January 9, 2017

Re: 3300-10-037, Chinese Bible Church of San Diego
Addendum to Visual Study

**Visual Resources Impact
Report
The Chinese Bible Church
of San Diego**

**PDS2014-SPA-14-001; PDS2010-3300-10-
037(MUP); PDS2010-3940-12-002(VAC);
PDS2014-3910-9508007L(ER)**

Distant View from West

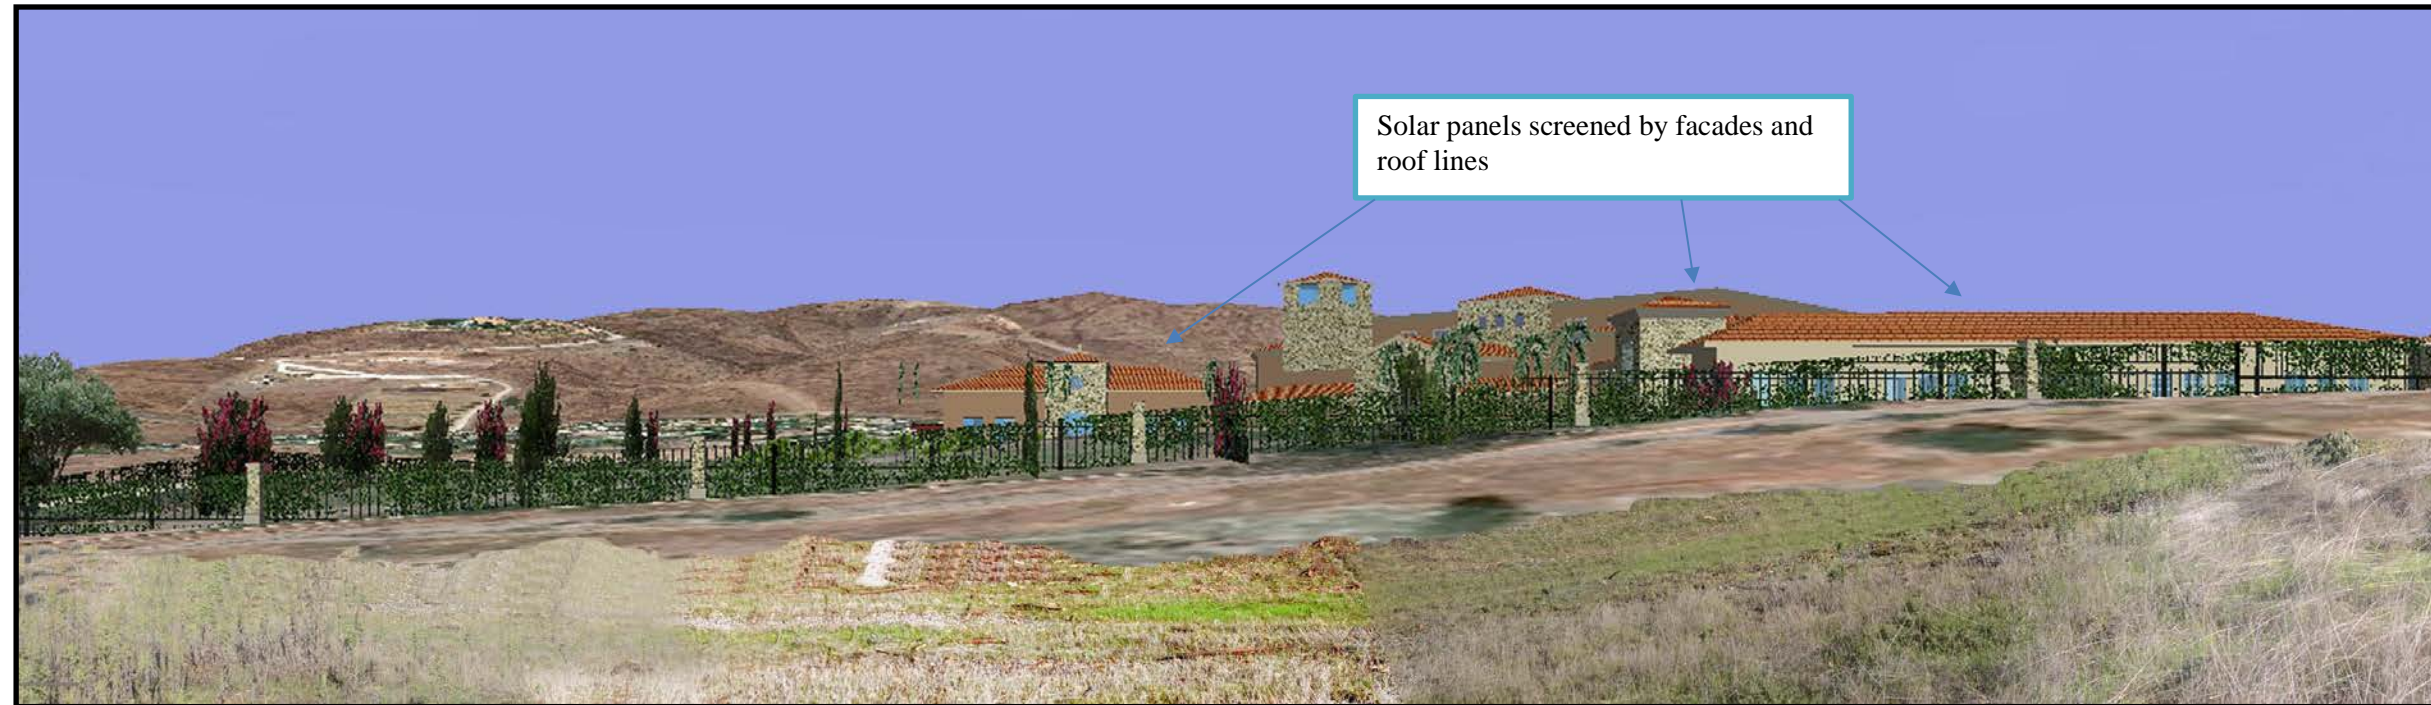
Three photo-simulations are provided that illustrate the resulting visual effect. These depict mid-distance, distant, and close-distance views. The mid-distance and distant views are at elevations above the site, while the close-distance view is approximately at the same level as the project. The simulations show that neither the structure of the panels nor glare would be visible. As shown, visual impact are avoided with the incorporation of these design measures.

1. Solar panels will be installed on the roofs of the buildings
2. Building facades will screen the panels from view
3. The surface of the solar panels will incorporate a non-glare finish
